# Planning and Zoning Commission

## Bridge Park, Block H 25-143AFDP

### Case Summary

**Siting**

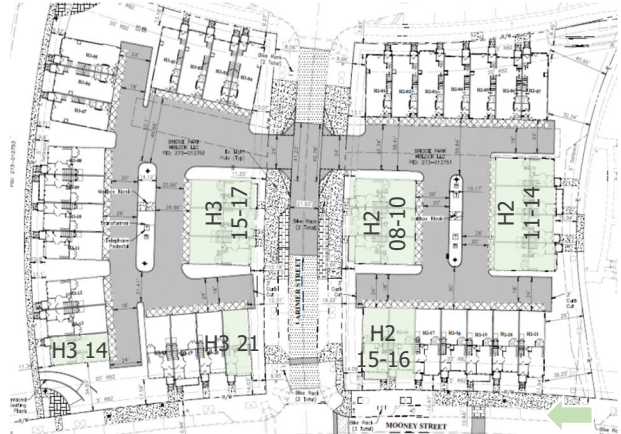
The site has constructions limitations due to the topography, which impacts the front property line coverage requirement at certain locations. Front property line coverage is not met along Dale Drive for Block H2 and along Dale Drive, John Shields Parkway and Mooney Street for Block H3. *Waivers are required to address this requirement.* Similar Waivers were supported at the previous approval in 2017. The RBZs are not shown correctly on the site plan, and the applicant is required to provide an updated site plan prior to the Building Permit stage, which is included as a condition of approval. Listed below is the building siting summary:

Single-Family Attached Building Type Siting Summary		
	Required	Met
Front RBZ	5-20 feet	Met
Front property line coverage	75%	Not Met at certain locations (Waivers requested) Block H2: 71% along Dale Drive Block H3: 50% along Dale Drive; 65% along John Shields Parkway Met at all other locations
